Final Environmental Impact Report

Deer Creek Mine Expansion
Surface Mining Permit and Reclamation Plan
Amendment No. PMR 19-001

Final Environmental Impact Report
(SCH# 2019049052)

INTRODUCTION & RESPONSE TO COMMENTS

Expanded Fenceline Receptor Map

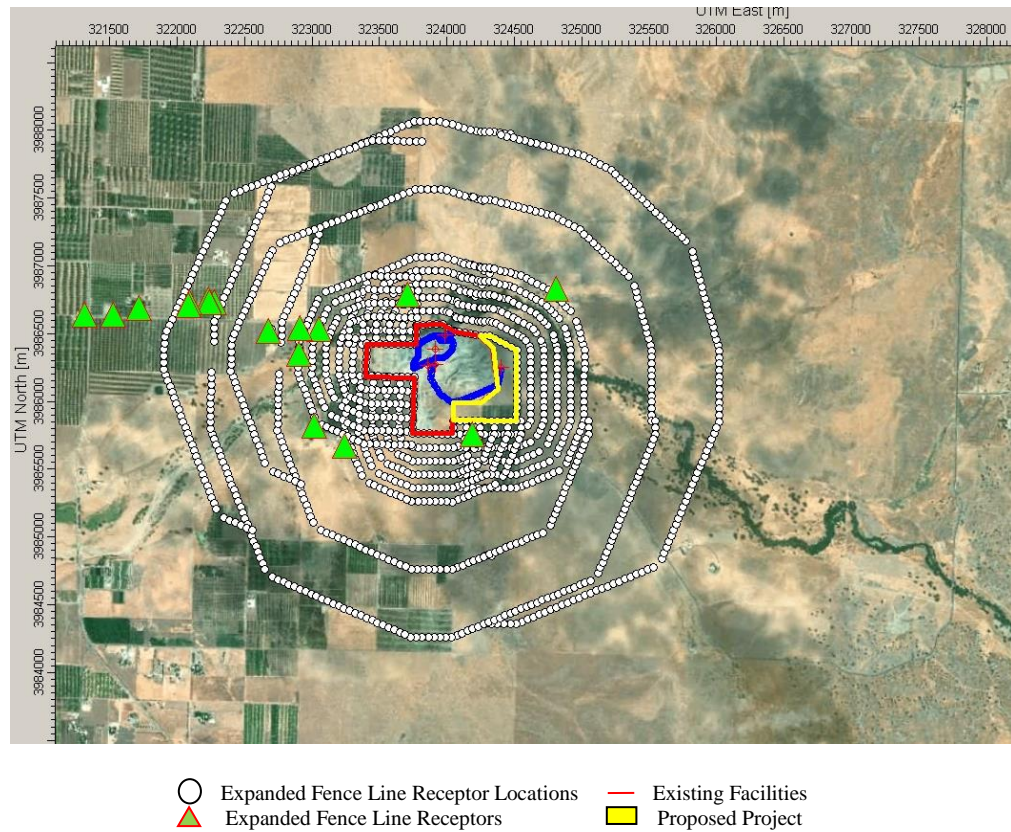
Comment 3: *The District recommends the HRA be revised in the areas of (A) emissions, (B) scenarios, (C) natural occurring asbestos, and (D) receptors (3(A) through 3(D)).*

3(D). Staff agrees with and supports the response provided by the subject matter expert, consultant MAQC. MAQC wrote, “The District’s policy guidance for siting receptors recommends the specification of a dense fence line receptor network of receptors to ensure that the maximum concentration would be expected to be contained within this grid network. However, the placement of receptor locations for the purposes of modeling an emission source’s air quality impacts in reality depends on the current and expected land use where such receptors would be located and the duration of exposure that these receptors would be subjected to emissions from the source.” The reality is that rural receptors within proximity of the Project are located predominantly to the north and west of the Project’s location, opposite of prevailing winds flow as shown in the wind rose from Porterville met data, below. The percentages are the directions FROM where the wind is blowing; as evident, the most frequent direction is FROM the northwest.

“The use of a dense fence line receptor network would be most appropriate in an urban setting where numerous sensitive receptors such as residences may be located in close proximity to an emission source. Such receptors could be exposed to both short term (1 hour and longer) and long term (years) exposures to a source’s emissions. It is, therefore, appropriate to use a detailed receptor grid (see figure below) to ensure that all residential sensitive receptors are covered within the air quality assessment as such receptors are within the “ambient air” where the general public has reasonable access.” “In the case of the Deer Creek Mine Expansion Project (project), however, the current density of residential use is less than 10 residences within a 1 mile radius of the center of the project. The areas surrounding the project are zoned as “Foothill Agriculture” within the Tulare County General Plan that limits the number of

residences within this land use to one single family unit for the entire contiguous property and a second home for each 40 acres in the entire property.” As such, the County agrees that based on the low receptor density, the use of an expanded fenceline receptor network as modeled by MAQC is appropriate for this Project. As noted earlier, rural receptors within proximity of Project are located predominantly to the north and west of the Project’s location, opposite of prevailing winds flow.

The County agrees with MAQC’s use of an expanded fenceline receptor approach because of the rural density in the Project’s vicinity and the unlikelihood of an individual remaining at the same location for more than eight hours. As noted by MAQC, “Given the sparse population and remote location of the project site, it is highly unlikely that a sensitive individual would 1) be located in close proximity to the project particularly along the project fence line and 2) that such an individual would remain at the same location for more than 8 hours (excepts as perhaps a worker). Therefore, it would not be appropriate to apply a dense fence line receptor network because of the remoteness of the project site and the lack of receptors that could be exposed to air emissions for longer than an average workday.”

Deer Creek Rock Co., Inc. Expansion
WB-67D Turning Maneuvers at SR 65 / Avenue 128 - Westbound Left/Right

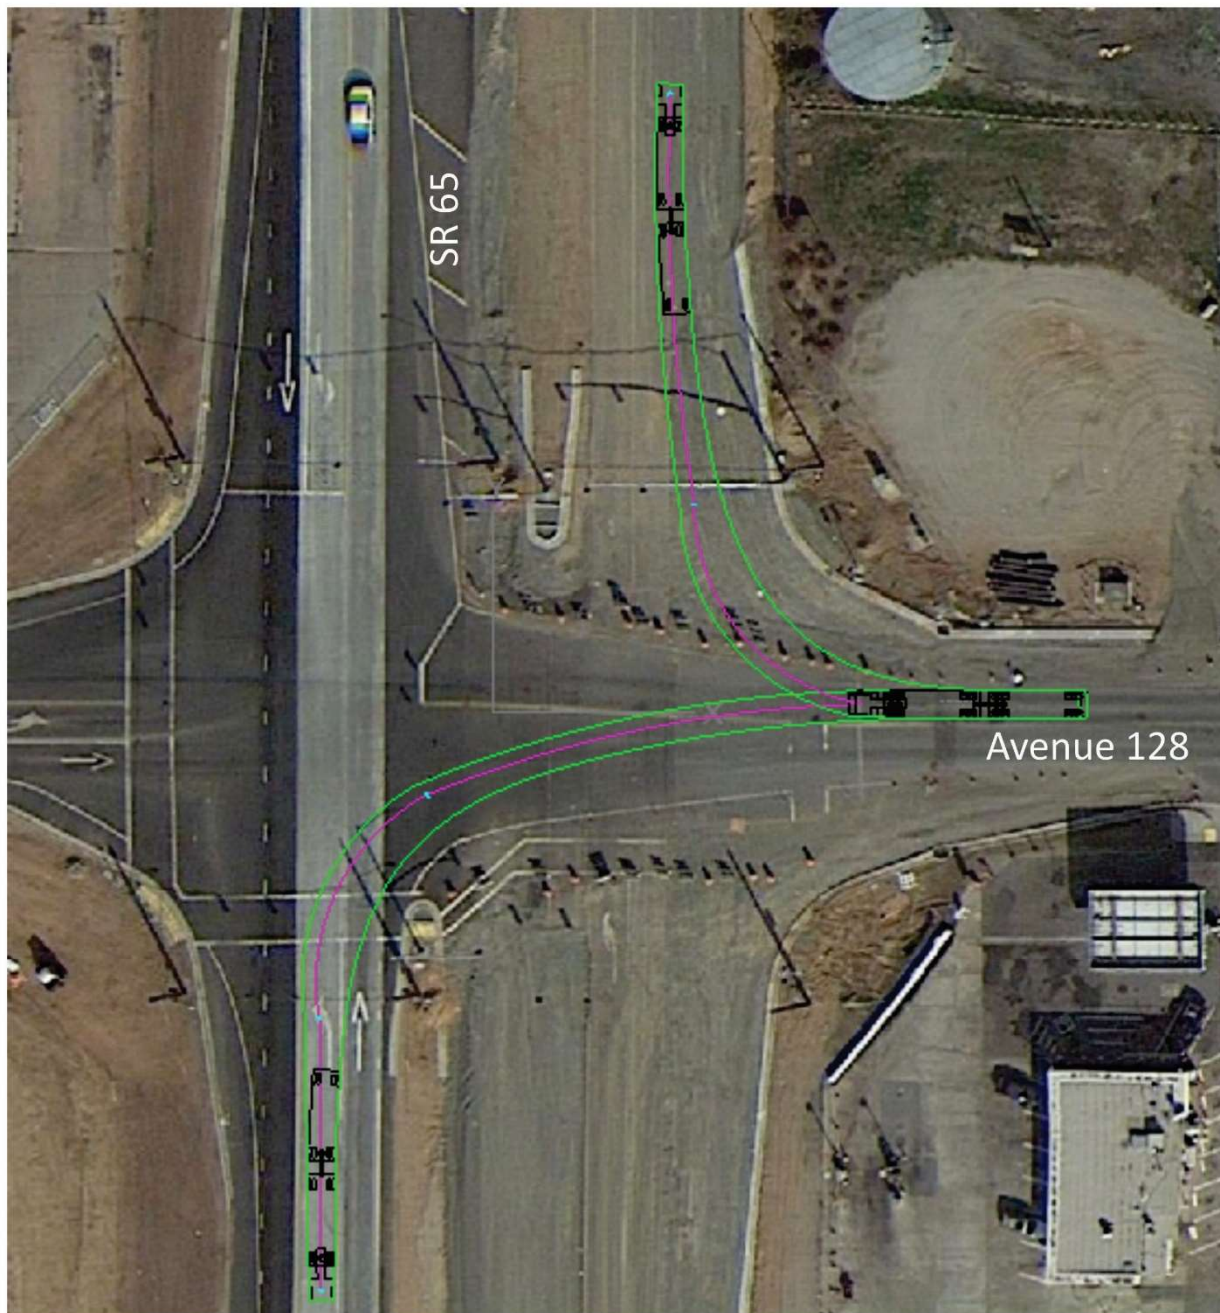
Comment 9: *"Figure 4.9-13 of the SEIR, truck turning template at the intersection of SR 65 and Avenue 128 needs to be updated and verified. Intersection improvements have been completed at this location. Caltrans recommends updating the figure map and verify the truck turning template is adequate for the Avenue 128 westbound (WB) right turn to SR 65 northbound (NB) and left turn to SR 65 southbound (SB). Please verify."*

Comment 9: “Figure 4.9-13 of the SEIR, truck turning template at the intersection of SR 65 and Avenue 128 needs to be updated and verified. Intersection improvements have been completed at this location. Caltrans recommends updating the figure map and verify the truck turning template is adequate for the Avenue 128 westbound (WB) right turn to SR 65 northbound (NB) and left turn to SR 65 southbound (SB). Please verify.”

Response: Staff agrees with and supports the response provided by the subject matter expert, consultant VRPA Technologies, Inc. (VRPA). VRPA wrote, "The truck turning template at the intersection of SR 65 and Avenue 128 considered the layout of the intersection upon completion of the improvements along SR 65. The truck turning template is therefore adequate for the Avenue 128 westbound (WB) right turn to SR 65 northbound (NB) and left turn to SR 65 southbound (SB)."

Response – Staff agrees with and supports the response provided by the subject matter expert, consultant VRPA Technologies, Inc. (VRPA). VRPA wrote, “The truck turning template at the intersection of SR 65 and Avenue 128 considered the layout of the intersection upon completion of the improvements along SR 65. The truck turning template is therefore adequate for the Avenue 128 westbound (WB) right turn to SR 65 northbound (NB) and left turn to SR 65 southbound (SB).”

Expanded Fenceline Receptor Map

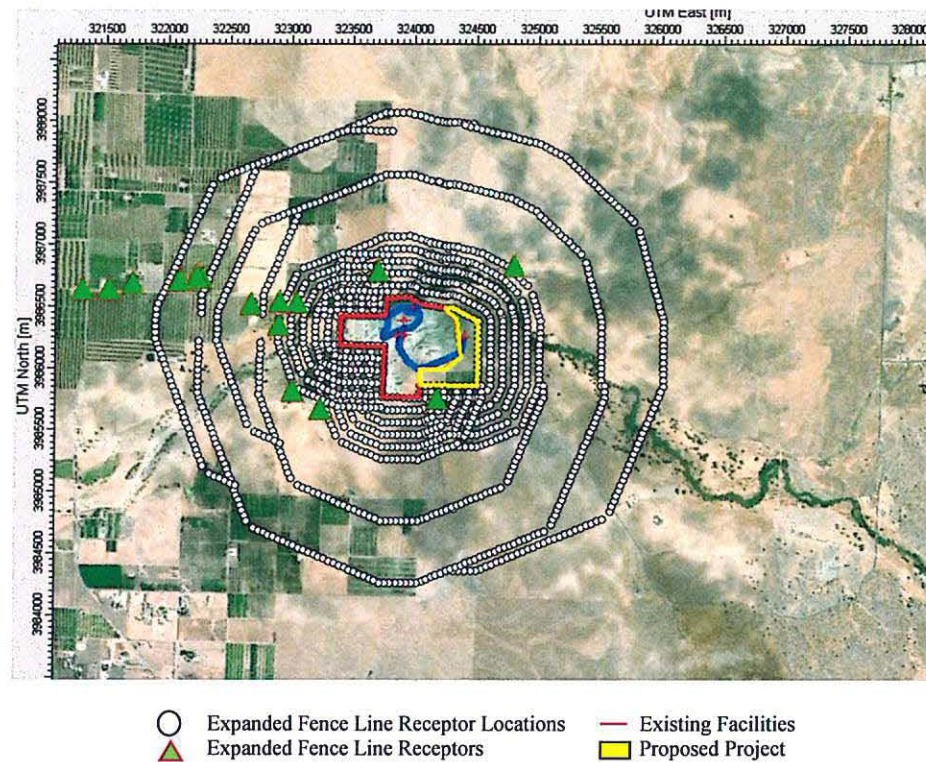
Comment 3: The District recommends the HRA be revised in the areas of (A) emissions, (B) scenarios, (C) natural occurring asbestos, and (D) receptors (3(A) through 3(D)).

“The use of a dense fence line receptor network would be most appropriate in an urban setting where numerous sensitive receptors such as residences may be located in close proximity to an emission source. Such receptors could be exposed to both short term (1 hour and longer) and long term (years) exposures to a source’s emissions. It is, therefore, appropriate to use a detailed receptor grid (see figure below) to ensure that all residential sensitive receptors are covered within the air quality assessment as such receptors are within the “ambient air” where the general public has reasonable access.” “In the case of the Deer Creek Mine Expansion Project (project), however, the current density of residential use is less than 10 residences within a 1 mile radius of the center of the project. The areas surrounding the project are zoned as “Foothill Agriculture” within the Tulare County General Plan that limits the number of residences within this land use to one single family unit for the entire contiguous property and a second home for each 40 acres in the entire property.” As such, the County agrees that based on the low receptor density, the use of an expanded fenceline receptor network as modeled by MAQC is appropriate for this Project. As noted earlier, rural receptors within proximity of Project are located predominantly to the north and west of the Project’s location, opposite of prevailing winds flow.

The County agrees with MAQC’s use of an expanded fenceline receptor approach because of the rural density in the Project’s vicinity and the unlikelihood of an individual remaining at the same location for more than eight hours. As noted by MAQC, “Given the sparse population and remote location of the project site, it is highly unlikely that a sensitive individual would 1) be located in close proximity to the project particularly along the project fence line and 2) that such an individual would remain at the same location for more than 8 hours (excepts as perhaps a worker). Therefore, it would not be appropriate to apply a dense fence line receptor network because of the remoteness of the project site and the lack of receptors that could be exposed to air emissions for longer than an average workday.”

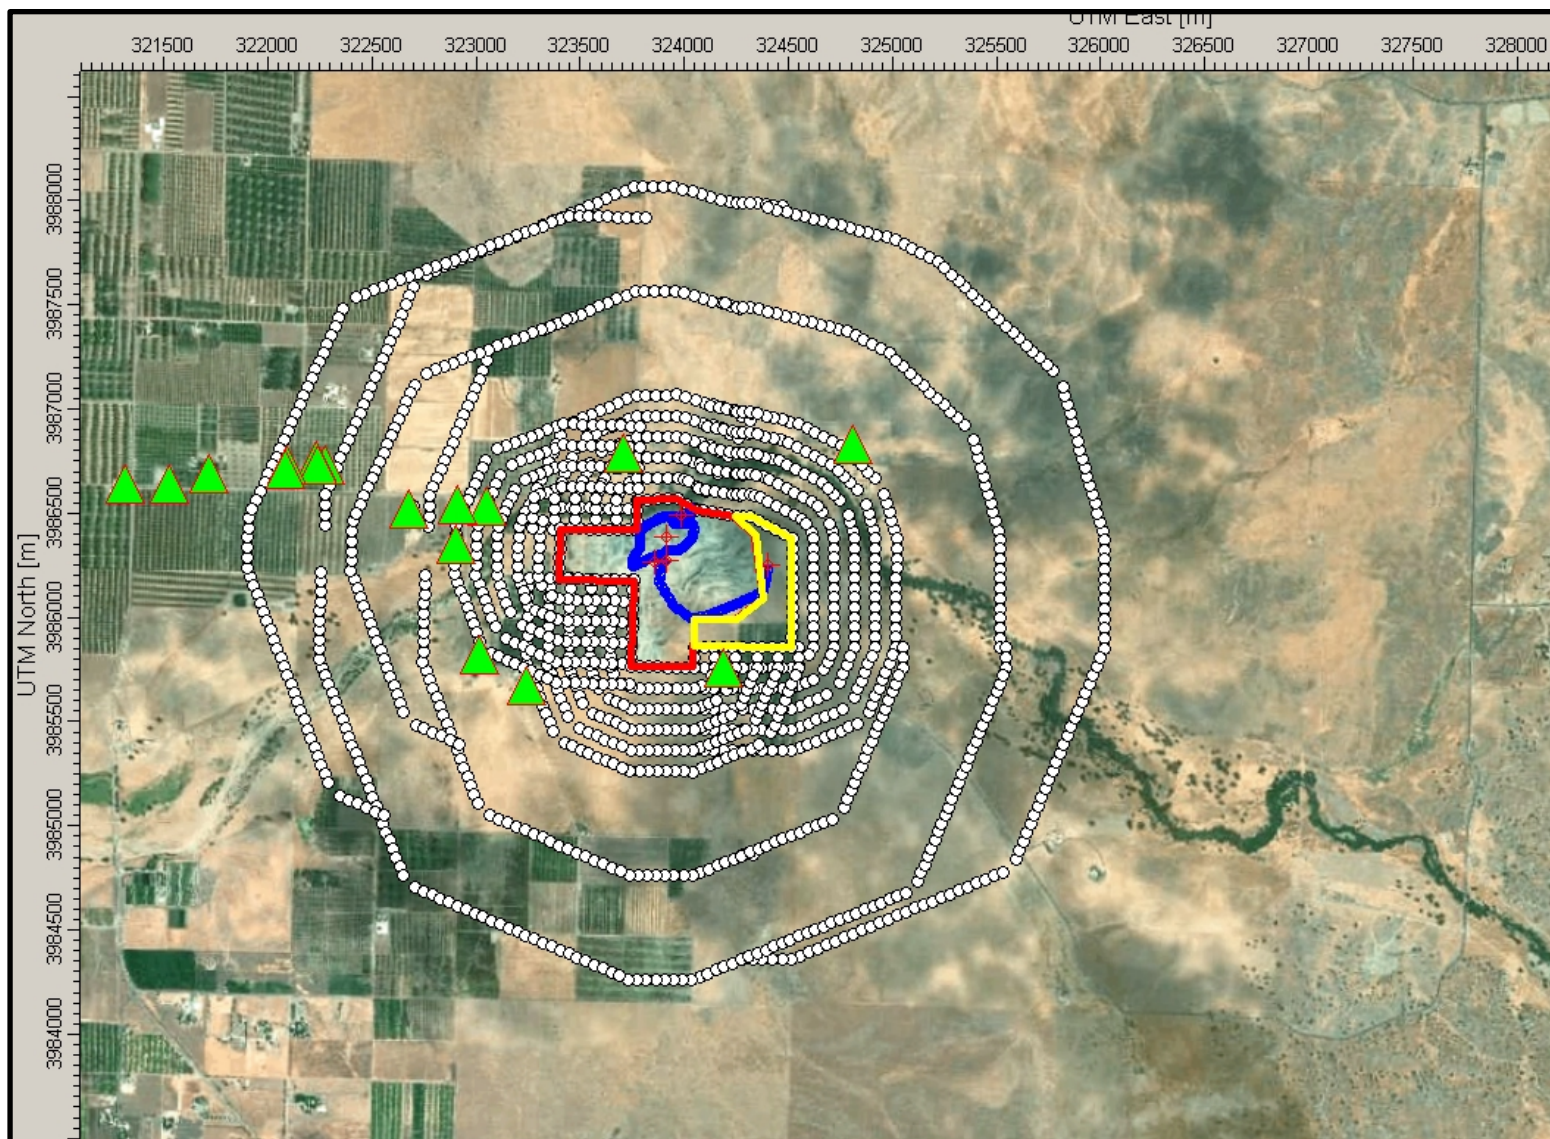
Comment 3D: The Ambient Air Quality Analysis (AAQA) performed for the criteria emissions were performed inappropriately as the only receptors used were actual receptors. When performing an AAQA it is also necessary to place receptors in 'ambient air' (that portion of the atmosphere to which the general public has reasonable access). This is usually accomplished by using fence line gridding from the facility boundary. Please refer to District Policy APR-1925 for District guidance on how to perform AAQAs. District Policy APR-1925 is available online at the following link. <https://www.valleyair.org/policies/per/Policies/APR-1925.pdf>.

Response 3d: The District's policy guidance for siting receptors recommends the specification of a dense fence line receptor network of receptors to ensure that the maximum concentration would be expected to be contained within this grid network. However, the placement of receptor locations for the purposes of modeling an emission source's air quality impacts in reality depends on the current and expected land use where such receptors would be located and the duration of exposure that these receptors would be subjected to emissions from the source.

The use of a dense fence line receptor network would be most appropriate in an urban setting where numerous sensitive receptors such as residences may be located in close proximity to an emission source. Such receptors could be exposed to both short term (1 hour and longer) and long term (years) exposures to a source's emissions. It is, therefore, appropriate to use a detailed receptor grid to ensure that all residential sensitive receptors are covered within the air quality assessment as such receptors are within the "ambient air" where the general public has reasonable access.
